Service Bulletin: EMI Filter Too Close to Power Switch Bracket	
Prepared by: Maxwell Anderson	Date Prepared: 6/6/2022	Models Affected: T101-07 (HTM1382-01/HTM1376-01)

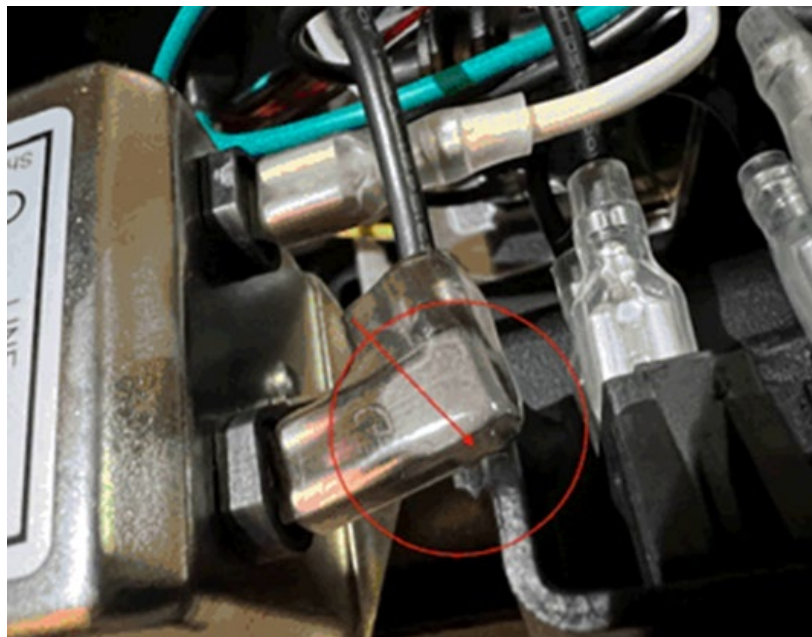
During production some units had the EMI filter incorrectly installed next to the power switch bracket, resulting in sparks coming from under the motor compartment.

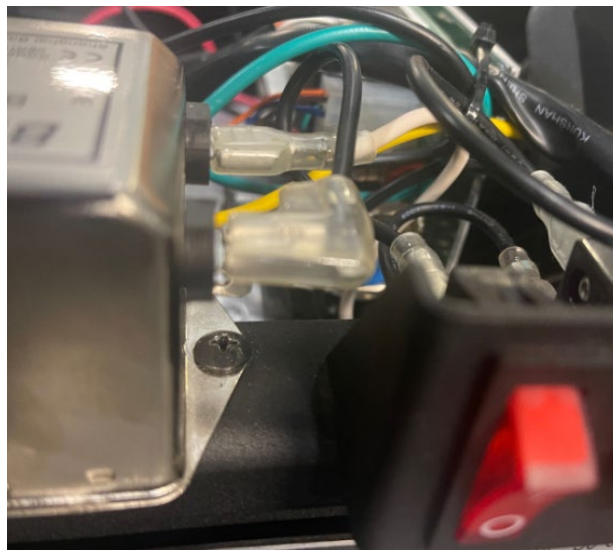
5. Use a Phillips head screwdriver to loosen the two screws securing the EMI filter to the frame. With both screws loose, but not removed, shift the EMI filter box away from the power switch bracket.

6. Install the new EMI wire (019378-A) and check that enough clearance is given to prevent it from rubbing against the power switch bracket.
